**PLANNING COMMISSION MEETING**  
**LOCATION: TOWNSHIP ANNEX, 7527 HIGHLAND, WHITE LAKE, MICHIGAN 48383**  
**(FORMER WHITE LAKE LIBRARY)**  
**THURSDAY, OCTOBER 21, 2021 – 7:00 PM**

**RE: Pontiac Lake Overlook (FKA Pontiac Lakeview Apartments)- Final Site Plan/Final Engineering Plan-2<sup>nd</sup> Review**

**Subject:** 8565 Pontiac Lake Road  
Pontiac Lake Overlook Apartments Final Site Plan Review #2  
Tax Parcel No. 12-13-328-003

**RE: 8565 Pontiac Lake Road  
Pontiac Lake Overlook Apartments Final Site Plan Review – 2<sup>nd</sup> Review  
Parcel Number 12-13-328-003**

LP-1

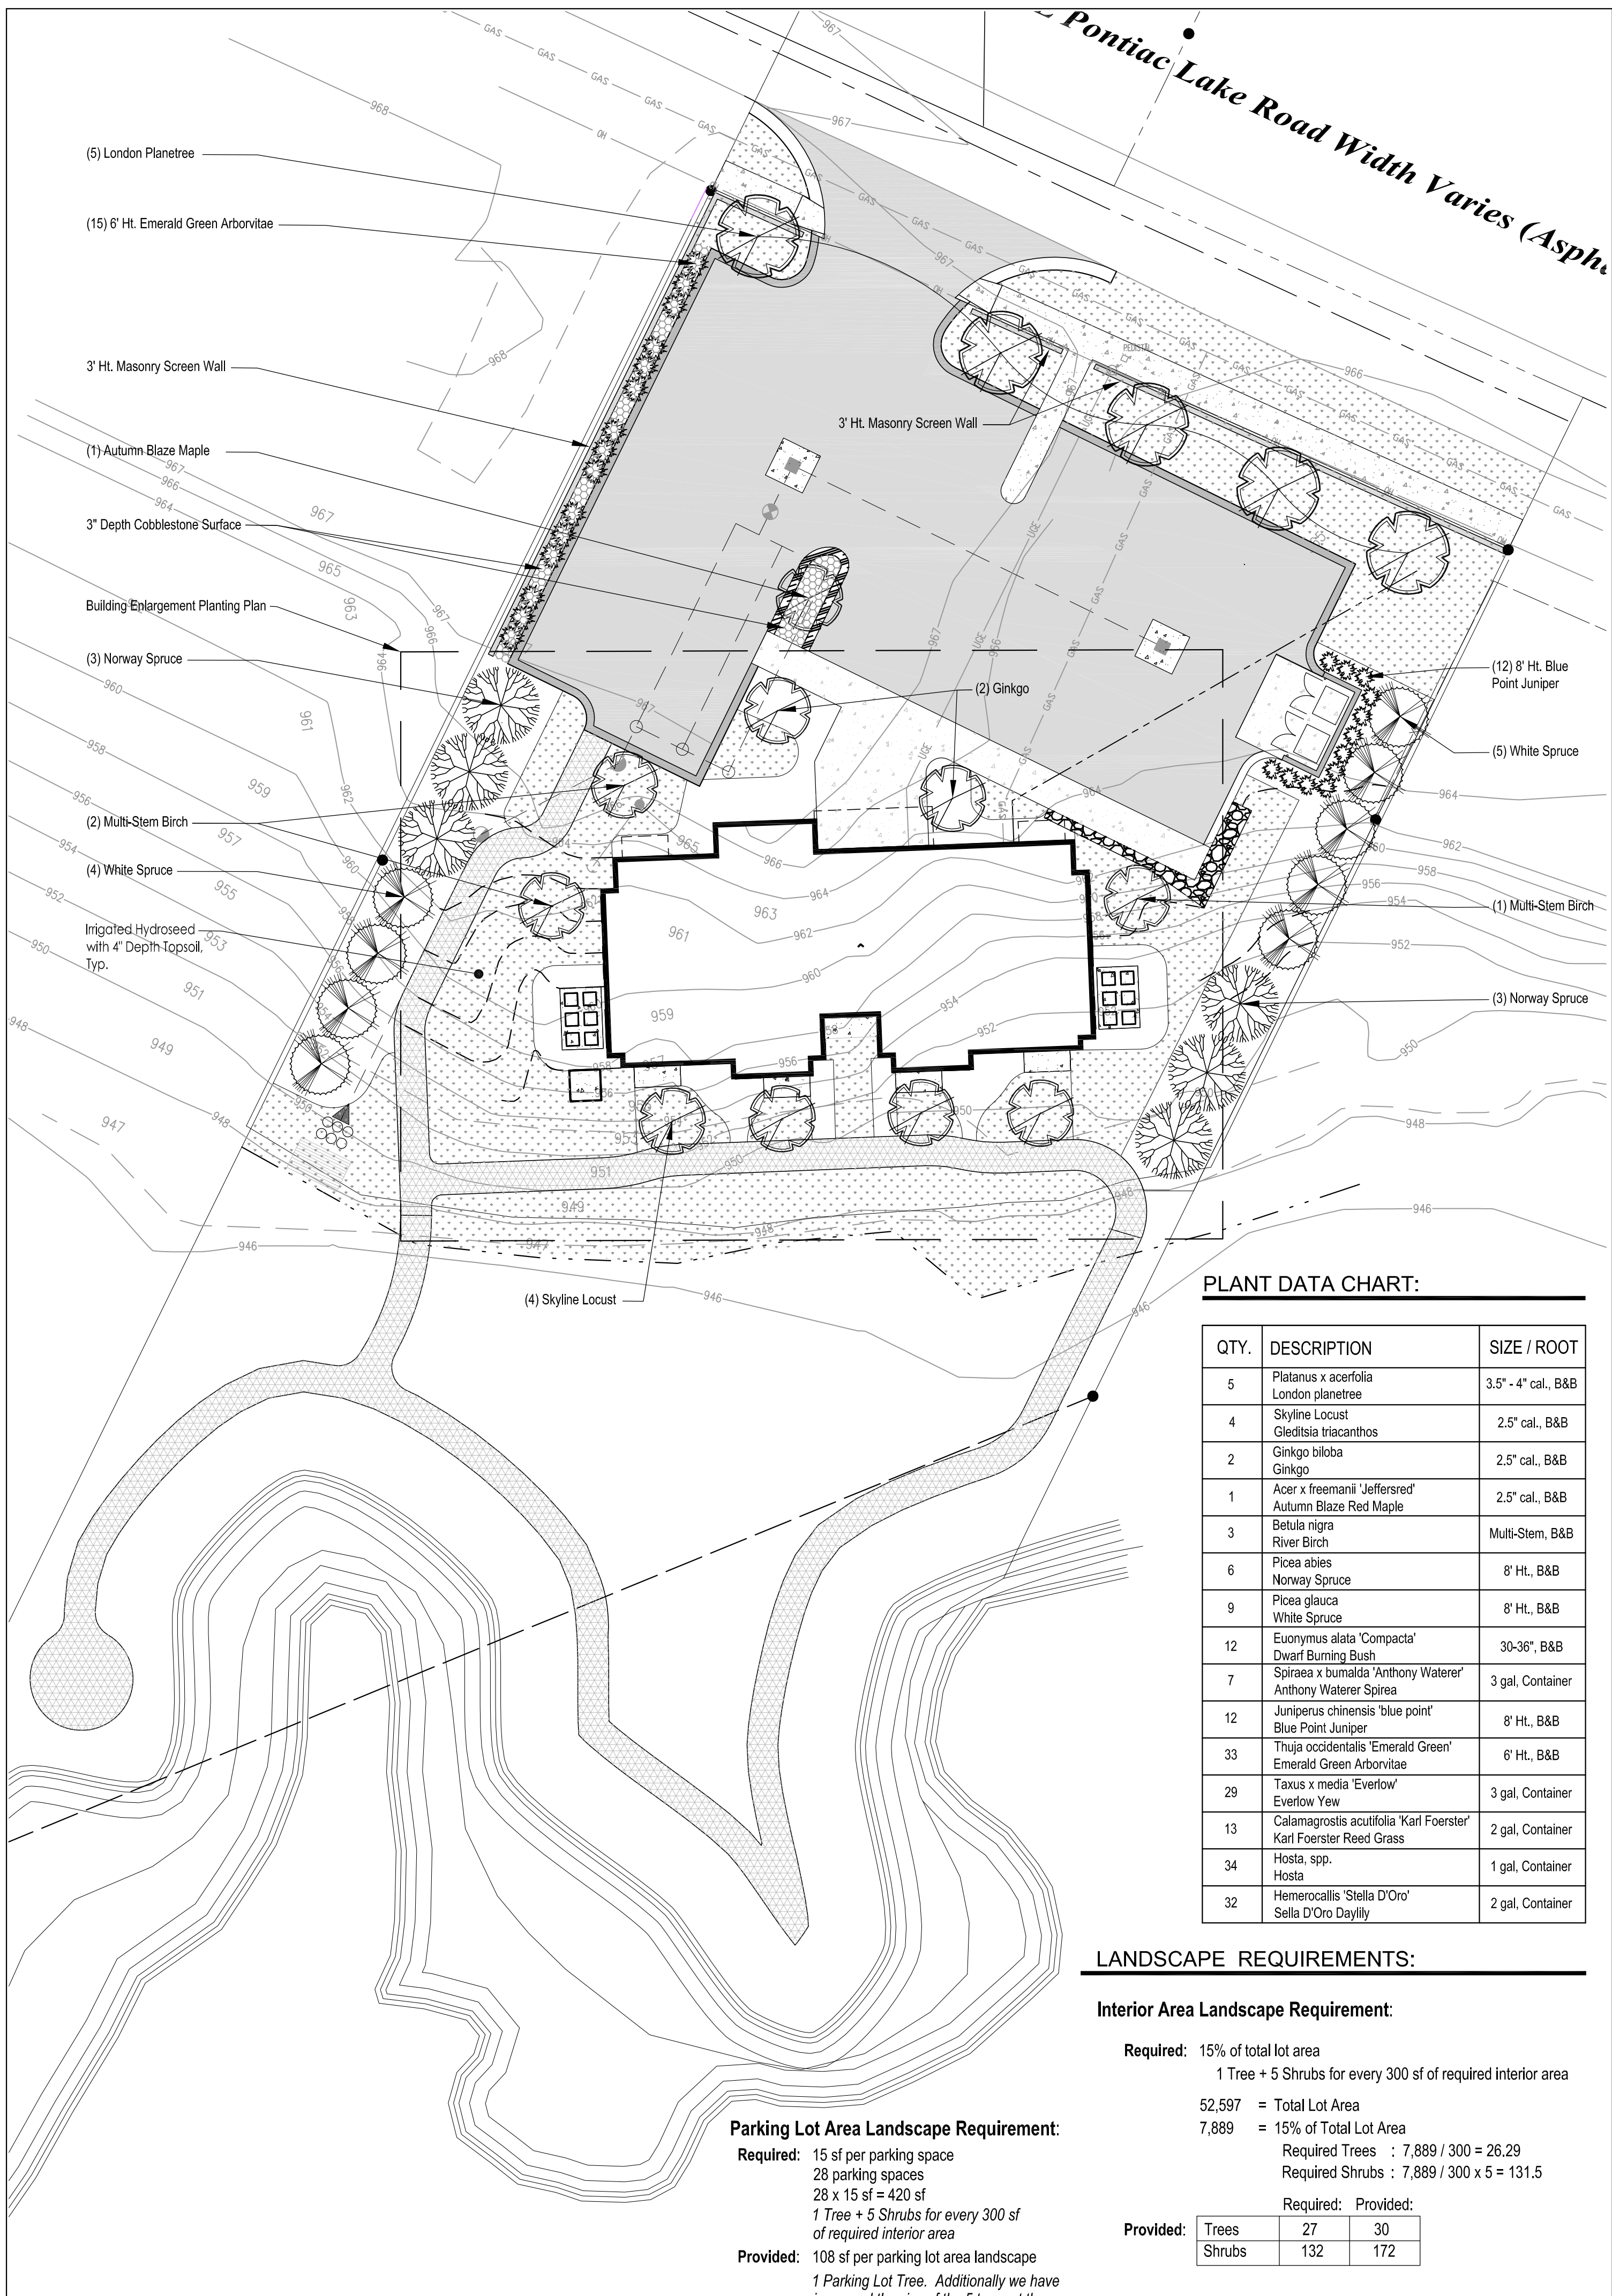
- 3-foot masonry screen wall along the north and west property lines. – **the landscape plan shows the required screen wall. However, a detail drawing of the wall was not provided. A typical cross-section of the wall shall be provided for review and approval. Additionally, the site plan notes a “concrete screen wall” on the west side of the parking area. Masonry is required, and the site plan does not show the required wall north of the parking area along Pontiac Lake Road. The site plan shall be revised to show a masonry screen wall in the location required by the ZBA. The site construction plan was revised to show a masonry screen wall in the location required by the ZBA, and a screen wall detail was provided on the Notes & Details sheet. However, this is inconsistent with the architectural site plan, which indicates “brick pier w/ limestone cap, alum fence between piers. (Typical along Pontiac Lake Road).” A detail of the proposed pier and fence shall be provided for review to confirm satisfaction of the ZBA condition. The site construction plans and architectural site plan shall be consistent; revise accordingly.**

- Other: Note 12 of the Planting Notes indicates hydroseed installed at all lawn areas depicted on the drawing. – **sod shall be required. Revise landscape plan and Planting Note 12 accordingly. Comment partially addressed. Note 12 was updated accordingly. The indication on the left side of the landscape plan stating "Irrigated Hydroseed..." shall be revised to sod.**

- 3-foot masonry screen wall along the north and west property lines. – **the landscape plan shows the required screen wall. However, a detail drawing of the wall was not provided. A typical cross-section of the wall shall be provided for review and approval. Additionally, the site plan notes a “concrete screen wall” on the west side of the parking area. Masonry is required, and the site plan does not show the required wall north of the parking area along Pontiac Lake Road. The site plan shall be revised to show a masonry screen wall in the location required by the ZBA.**

- Other: Note 12 of the Planting Notes indicates hydroseed installed at all lawn areas depicted on the drawing. – **sod shall be required. Revise landscape plan and Planting Note 12 accordingly.**
